Register Reference: SD22A/0361 AI

Development: Demolition of all existing 1-3 storey industrial/commercial structures and small cafe on site totalling c.5, 500sq.m in area; Construction of a 1-5 storey Transitional Care Facility (step-up/step-down) providing 131 bedspaces over partial basement (total floor area c.6, 743sq.m) with central courtyard (c.519sq.m); The basement consists of a sprinkler tank and pump rooms, water tank room, plant room and workshop; Provision of dining and kitchen areas, sitting/family rooms, activity rooms, coffee dock, hair salon, oratory, lobbies/reception areas, ancillary offices and staff areas, stores, toilets, shower/changing facilities, ESB substation, generator, switchroom, service yard and waste areas serving the facility; Lobbies, stair/lifts, photovoltaic panels and green roofs throughout; Partial provision of the pocket park identified in the Tallaght LAP (c.1, 286sqm); New vehicular access from First Avenue and egress onto Cookstown Road via a one-way system through the subject site; Entrance signage on the eastern elevation of the proposed facility; All associated site development works, services provision, connection to the water supply, f

10. Internal Road Layout.

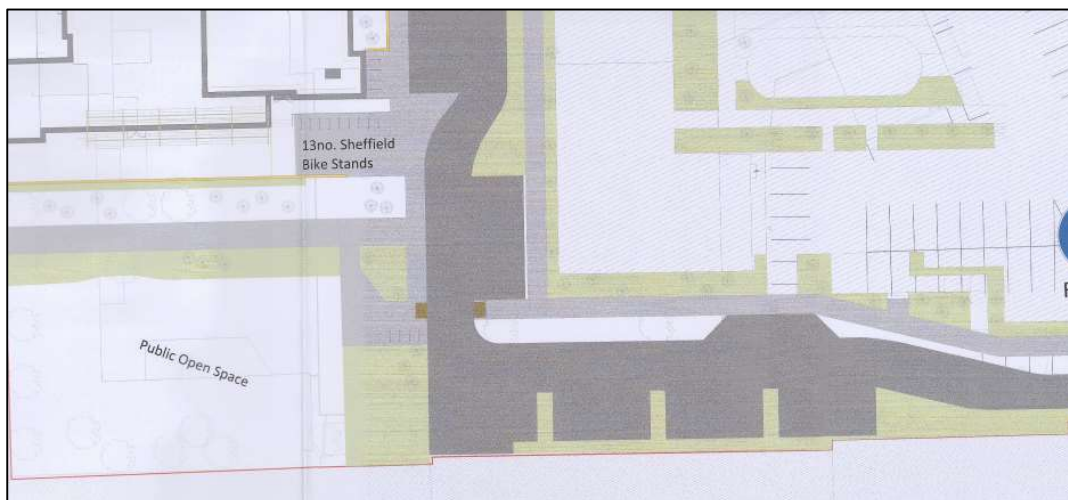
The applicant is requested to submit:

- (a) a layout of not less than 1:200 scale showing a revised internal road layout with a two-way system along with a vehicular link road running along the Northern boundary of the Park.
- (b) a layout of not less than 1:200 scale showing a Pedestrian Crossing with tactile paving and dropped kerb located between southern internal footpath and the Pocket Park.

10. (a) The applicant has not provided a two-way system through the development along with a vehicular link road running along the Northern boundary of the Park. This would inhibit vehicular and cyclist movement between Cookstown Road and the public park, and would seriously limit permeability around the park boundary and between neighbouring developments.

10. (b) SDCC Roads Department is satisfied with the applicant's provision of the pedestrian crossing.

In response to Item No. 10a, the single carriageway has been designed in accordance with best practice and compliance with DMURS. The overall layout and circulation routes reduce car dominance, promote traffic safety and prioritise pedestrian and cyclist activity. As such, car parking is limited and restricted to a single carriageway through the site.

In response to Item No. 10b, we refer to Drawing No. B981-OCSC-XX-XX-DR- C-0111 (Proposed Road Layout) prepared by OCSC. The pedestrian route leading from Cookstown Road across the internal road to the pocket park will comprise a footpath south of Block B (proposed under separate LRD proposal) crossing the internal road via a level crossing and continuing through the pocket park.

The proposed one way vehicular route through the site has been incorporated to reduce the dominance of road space through the development site and minimise unnecessary vehicular movements through the site, giving priority to pedestrians. Providing a 2 way road through the site would have a detrimental impact on the development layout and reduce space available for landscaping and safe pedestrian areas, whilst also reducing the area available for buildings on the site which would lead to necessary reductions in scale, efficiencies and viability of the development. There is no tangible and obvious benefit to the provision of a two-way road. With respect to the accessibility of the public park, it is noted that the section in the southeast corner of the development is just one portion of an overall park to be development in conjunction with the adjacent sites. This will provide multiples access routes to the park area facilitating access from all directions.
